FINAL PLAT OF "BUU QUANG TEMPLE" AN ADDITION TO WICHITA, SEDGWICK COUNTY, KANSAS IN THE NE 1/4 OF SECTION 21, T28S, R1E OF THE 6TH P.M.

RE: S/D 99-44— One-Step Final Plat of BUU QUANG TEMPLE ADDITION

STAFF REPORT
(One-Step Final Plat Approved 7/8/99)

CASE NUMBER: S/D 99-44 - BUU QUANG TEMPLE ADDITION

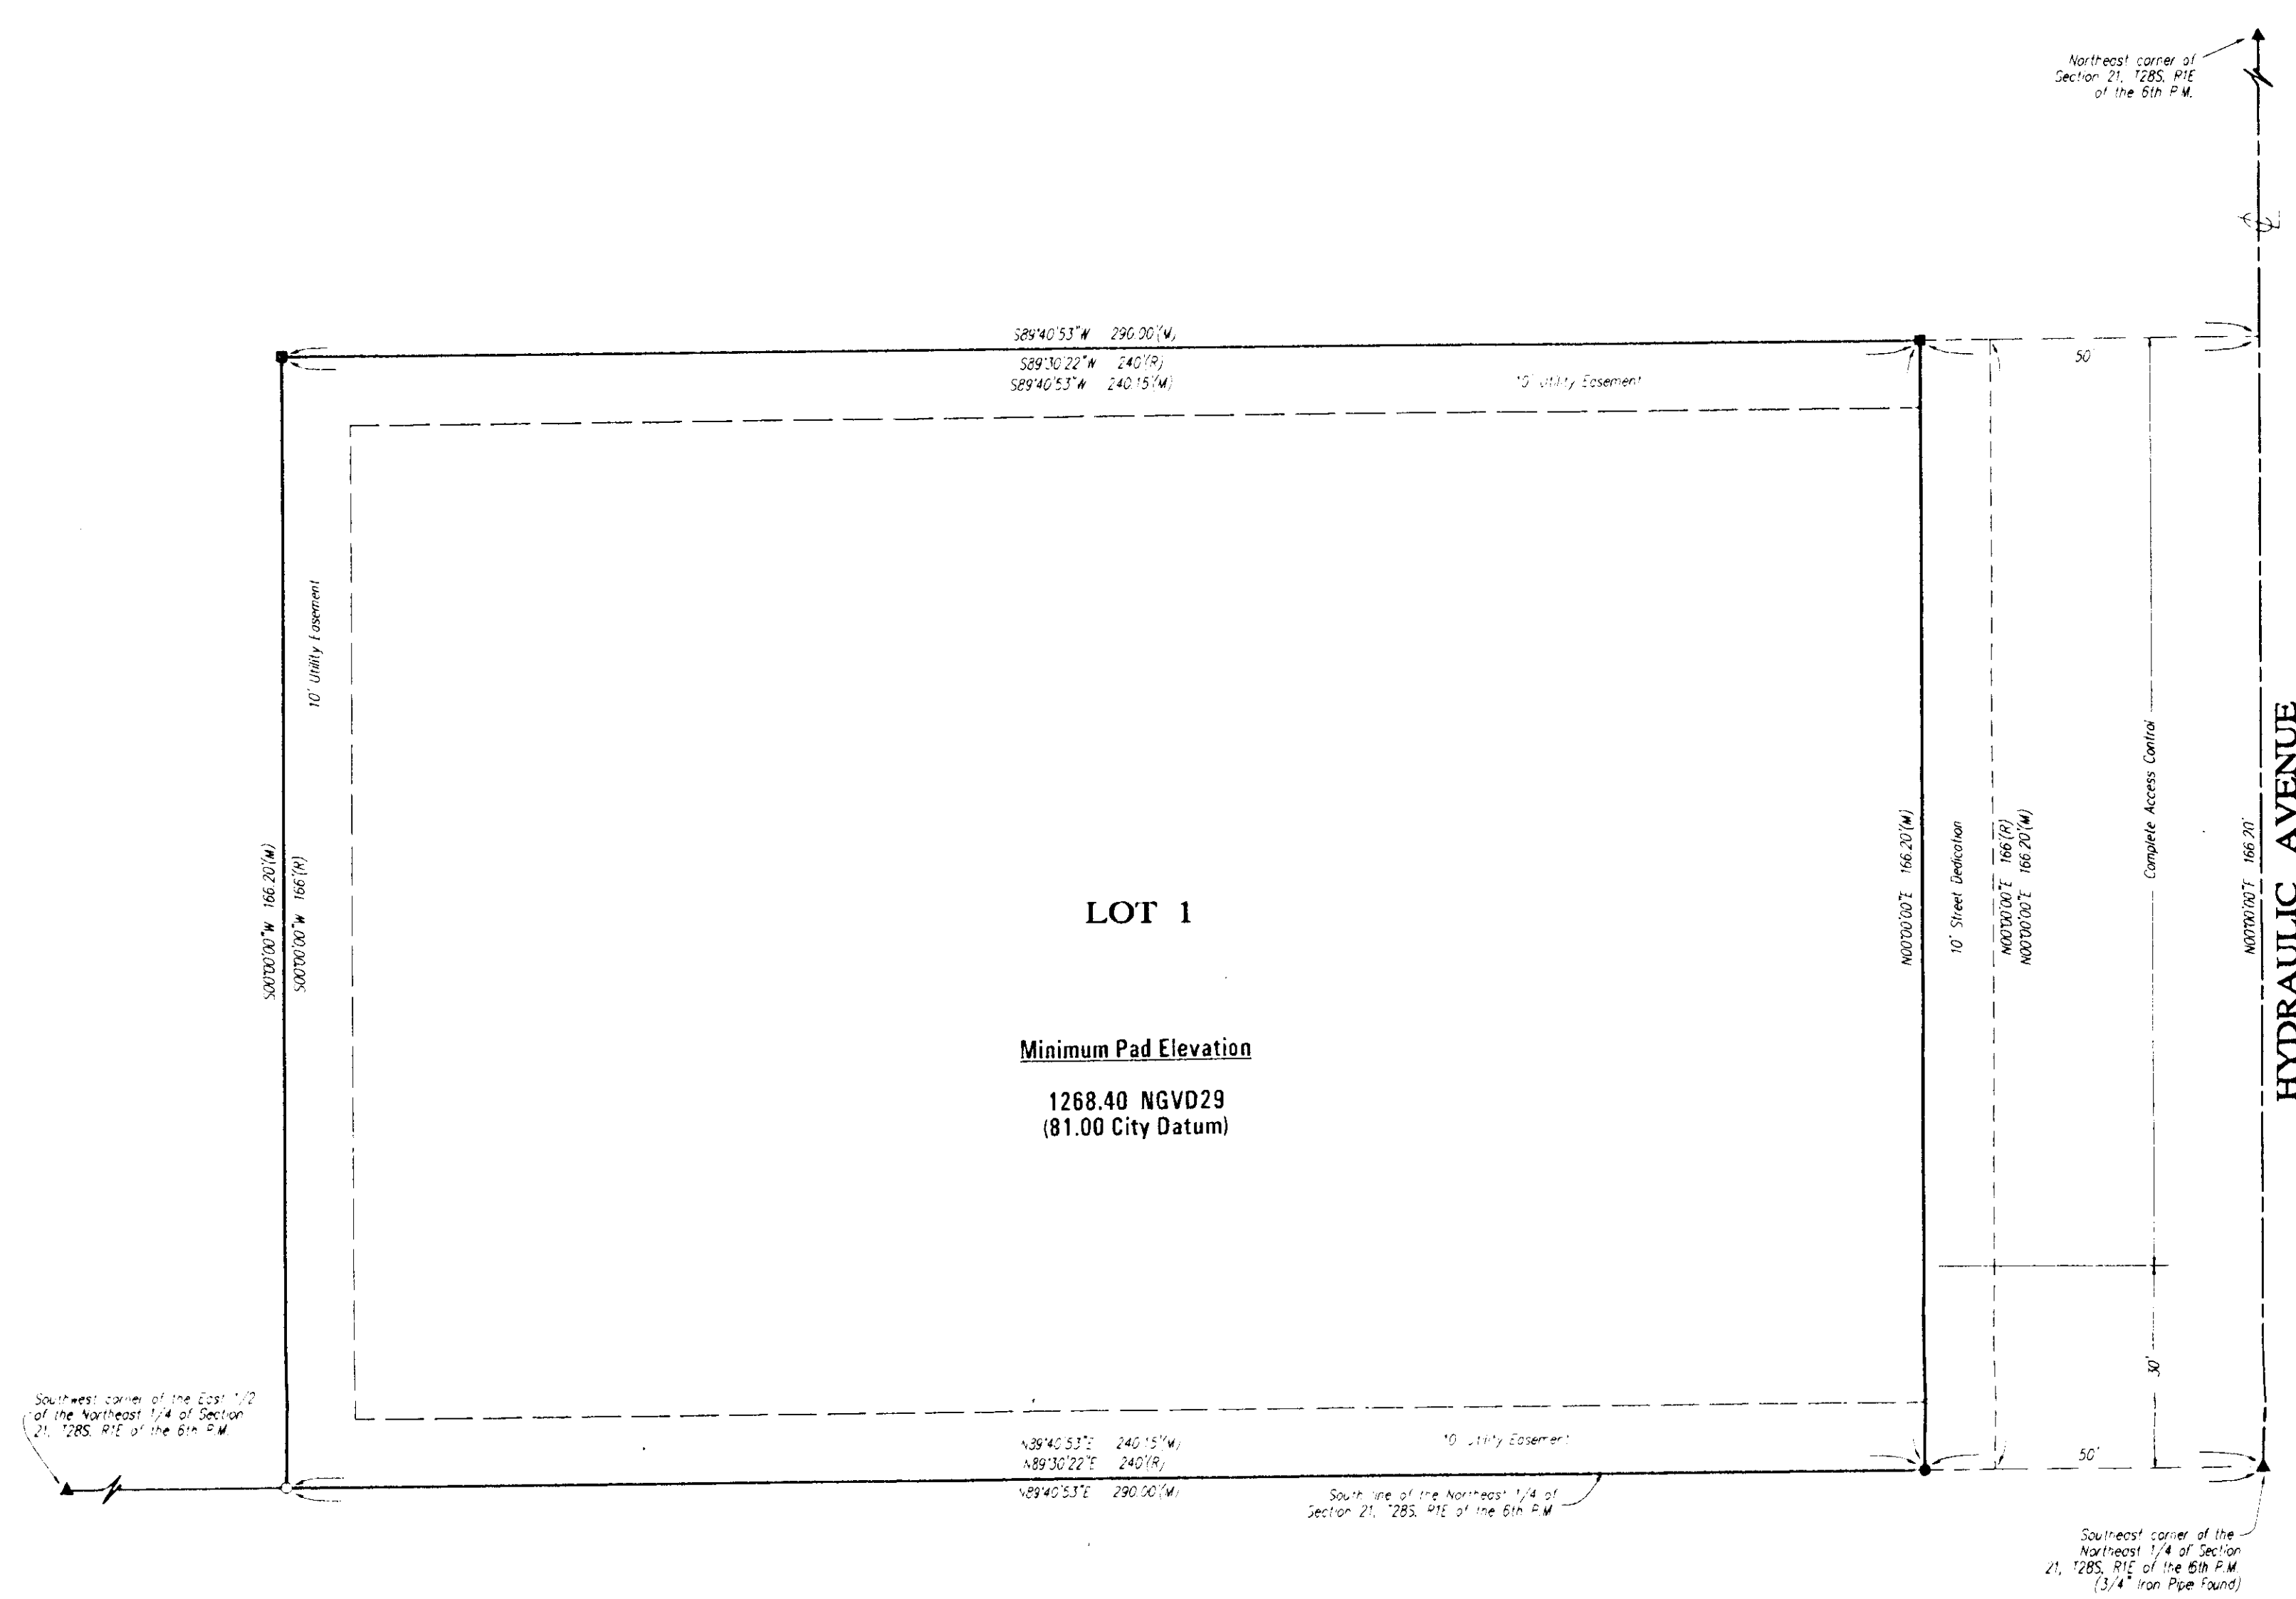
- A. ✓ Existing municipal services appear to be available to this site. **City Engineering** needs to comment on the need for any guarantees or easements. **No guarantees are required.**

- C. ✓ **City Engineering** needs to comment on the status of the applicant's drainage plan. **The drainage plan is approved.**
- D. ✓ **Traffic Engineering** needs to comment on the access controls. The plat denotes an existing access opening along the south 30 feet of the lot's frontage to Hydraulic. **The access controls are acceptable.**

- G. The platting text shall include language that a drainage plan has been developed for the plat and that all drainage easements, rights-of-way, or reserves shall remain at established grades or as modified with the approval of the applicable City or County Engineer, and unobstructed to allow for the conveyance of stormwater.
